Architectural Review Board Staff Report

Project Type: Site Development Section Plan, Lot 1

Location: 18600 Olive Street Road, Lot 1

Description: **18600 Olive Street Rd (Canaan Crossing, Lot 1)**: A Site Development Section Plan, Landscape Plan, Lighting Plan, Architectural Elevations and Architect's Statement of Design for a 1.06 acre tract of land zoned "PI" Planned Industrial District located south of Olive Street Road west of its intersection with Spirit Airpark West Drive.

Figure 2: Site Development Concept Plan

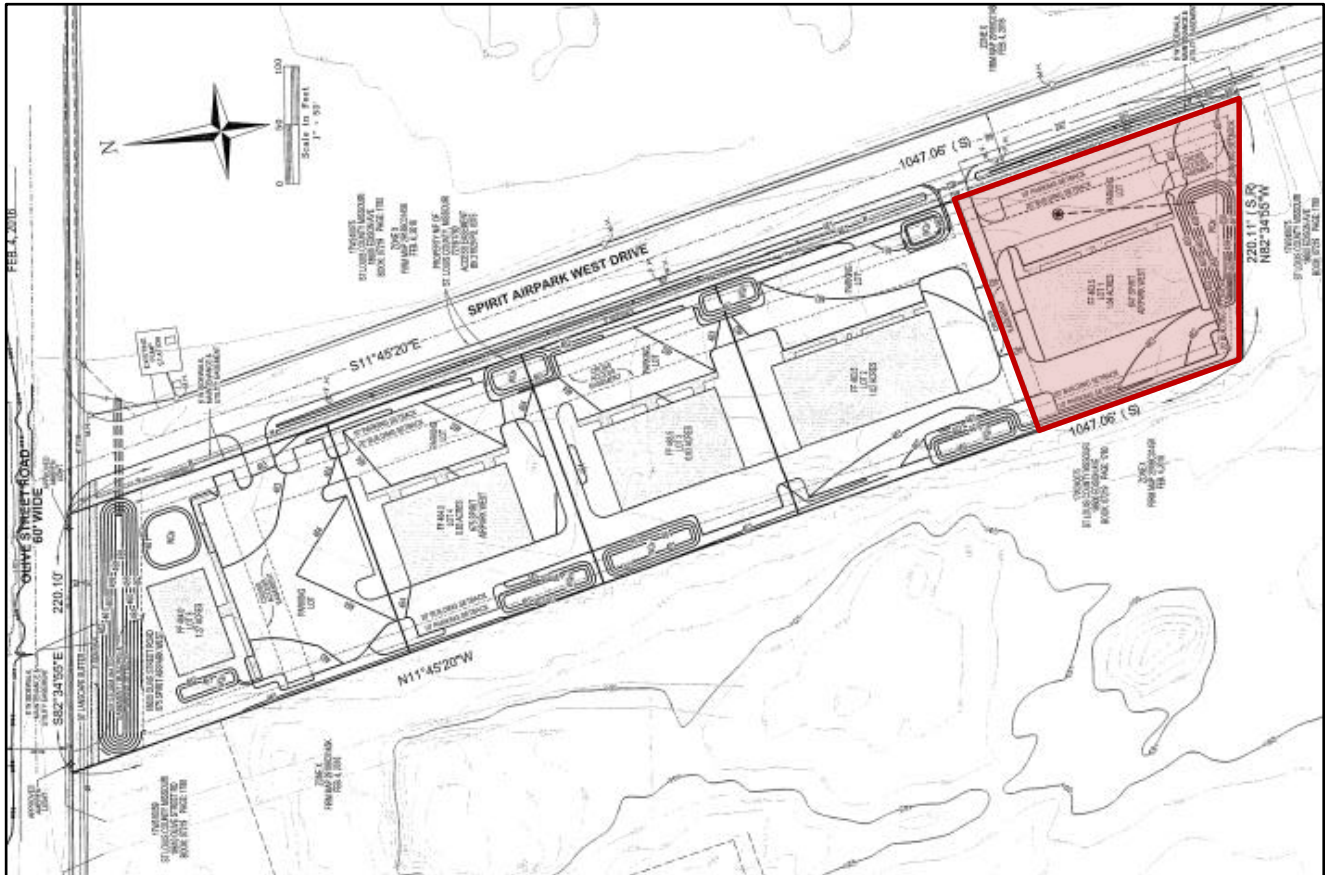
Additionally, the applicant will be required to provide a sidewalk along the eastern portion of the site as shown on the Site Development Concept Plan in Figure 2 below and will be required to provide internal pedestrian circulation to the building. While this is not shown on the plans presented today, this has been addressed in a comment on the plans to be addressed prior to review by the Planning Commission.
